July 15, 2022 GME Office Renovations University of Mississippi Medical Center

ADDENDUM NO. 02

3 INTERIOR PARTITION TYPE
12" = 1'-0"

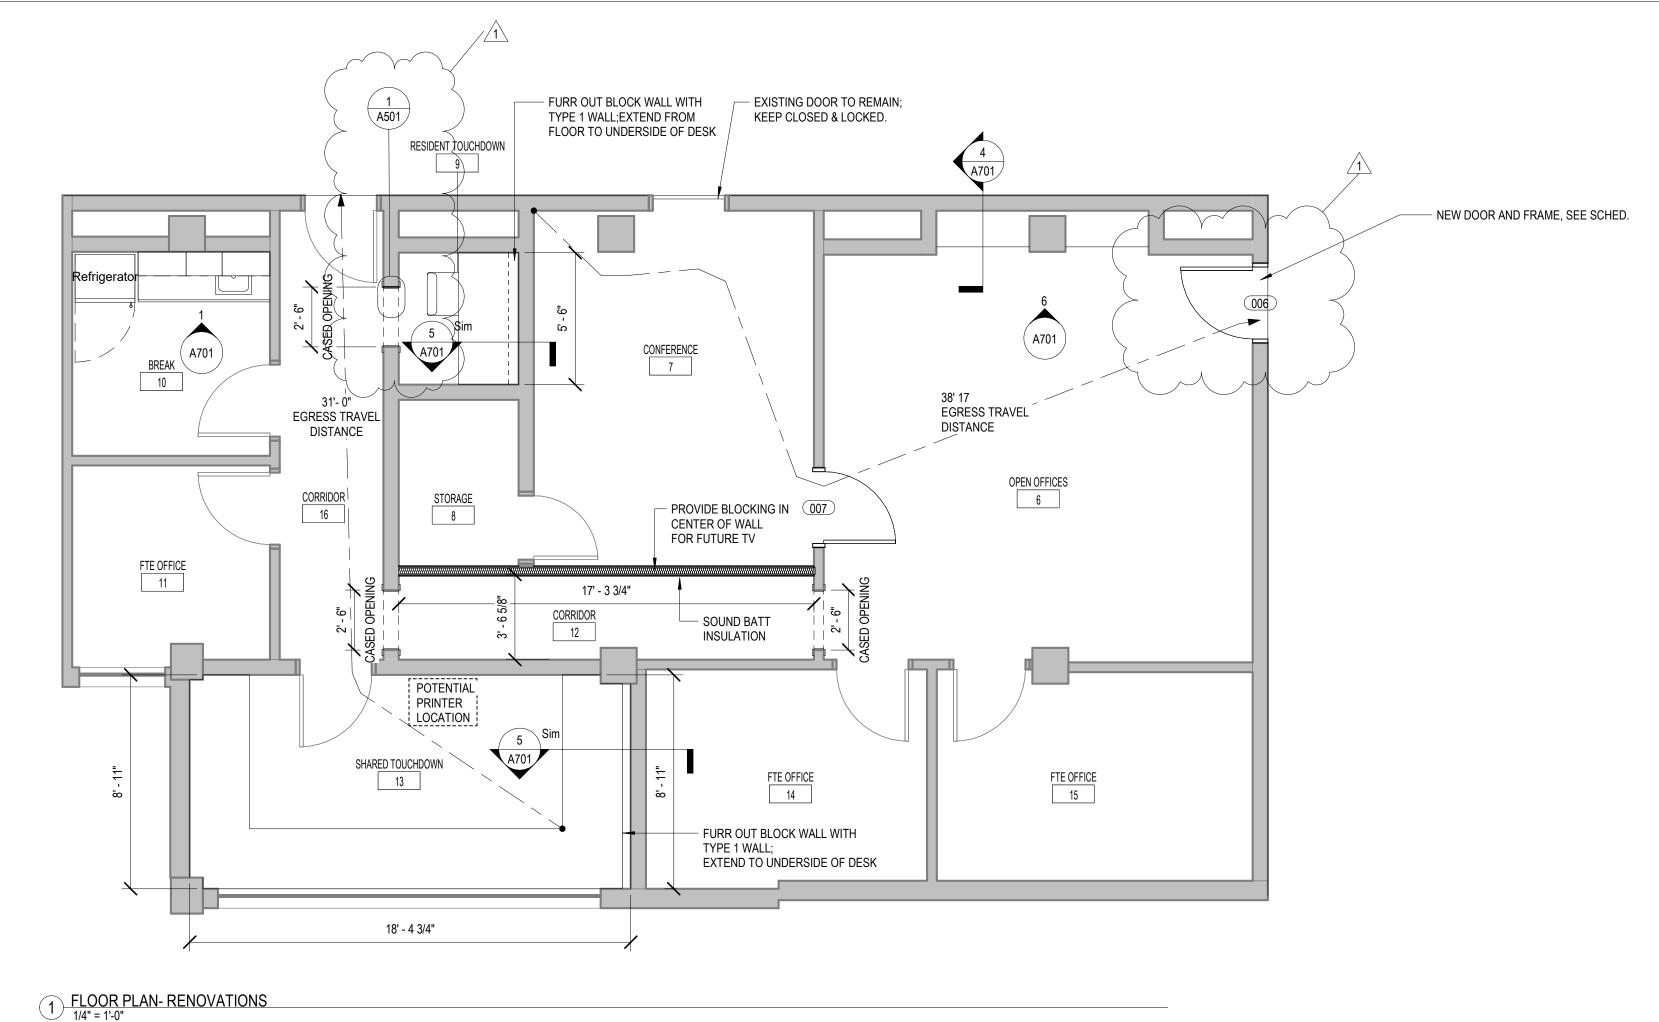
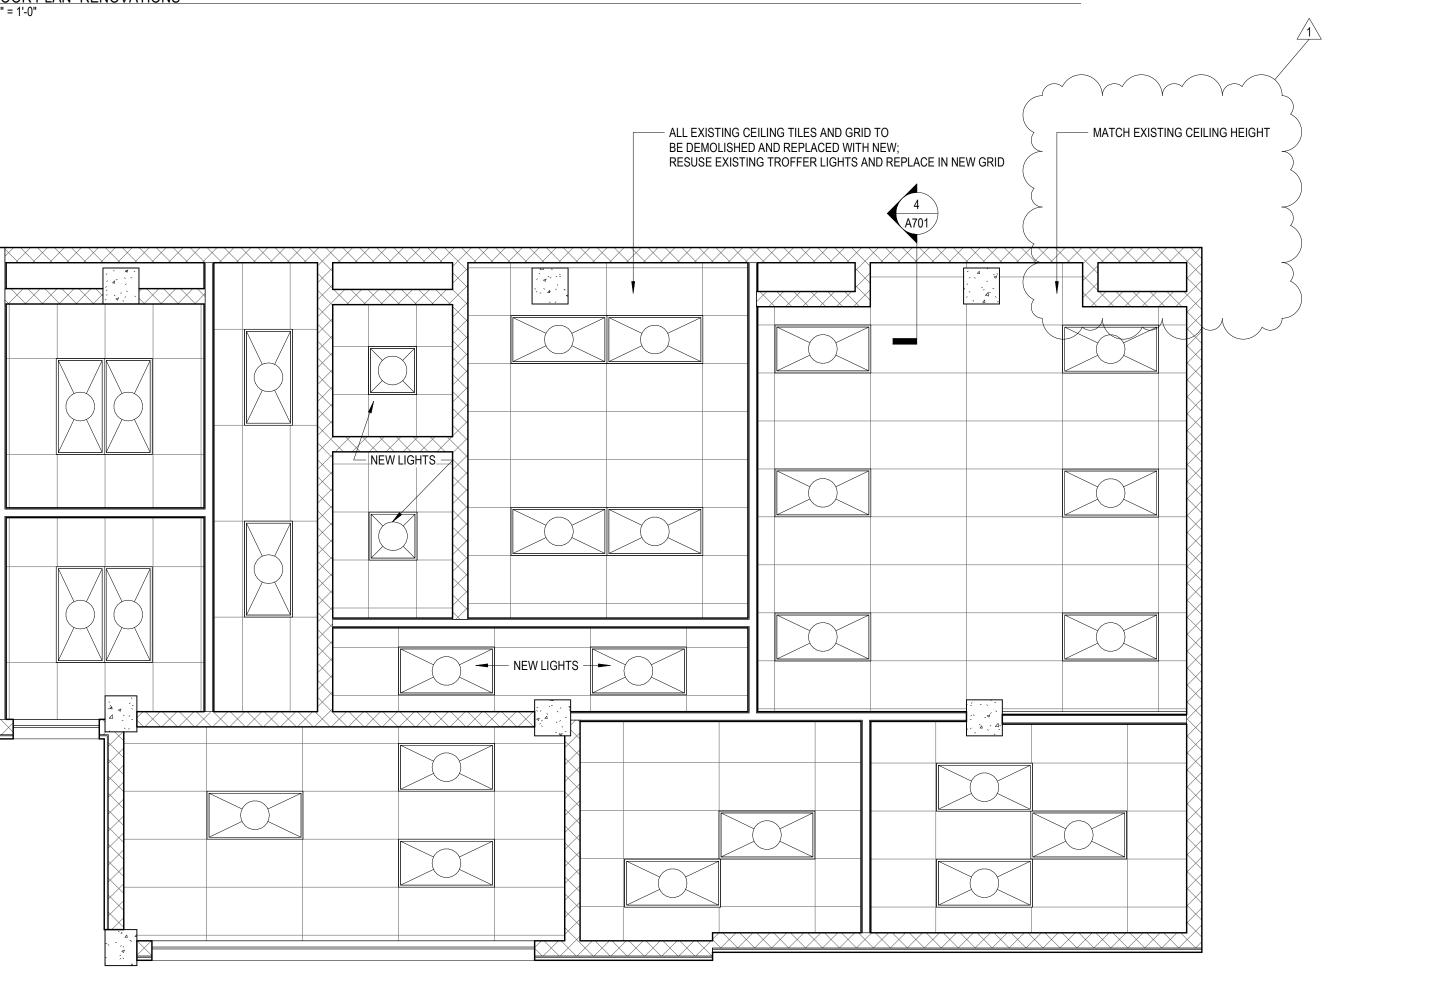
ITEM NO. 04 Wall Type 1

Revised wall Type 1 to be counter height. Detail 5/A701 revised to show transition between partition

wall and existing masonry at millwork.

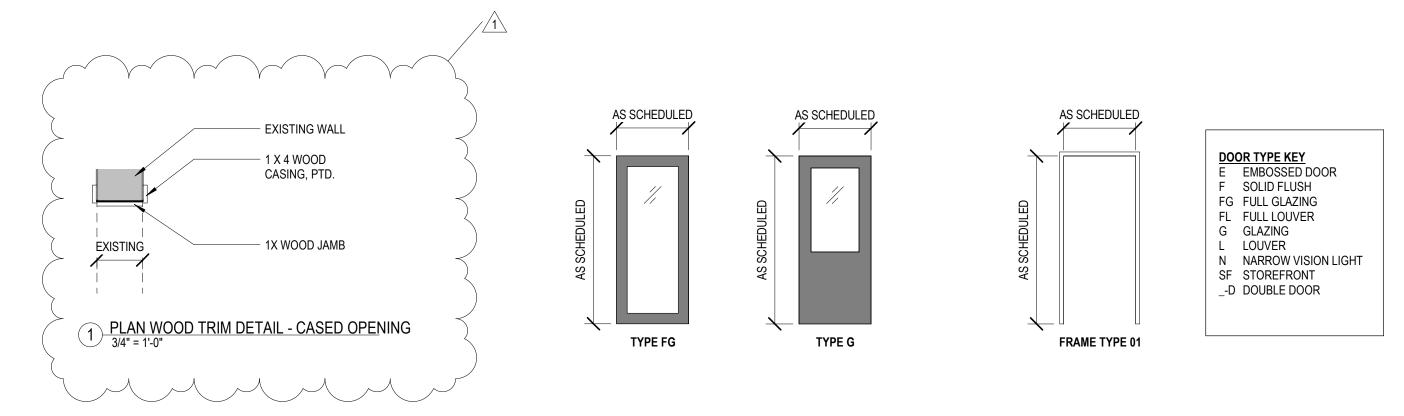
ITEM NO. 03 Door 006 A501

Provide new welded HM frame, solid core full lite glass door, and new hardware.
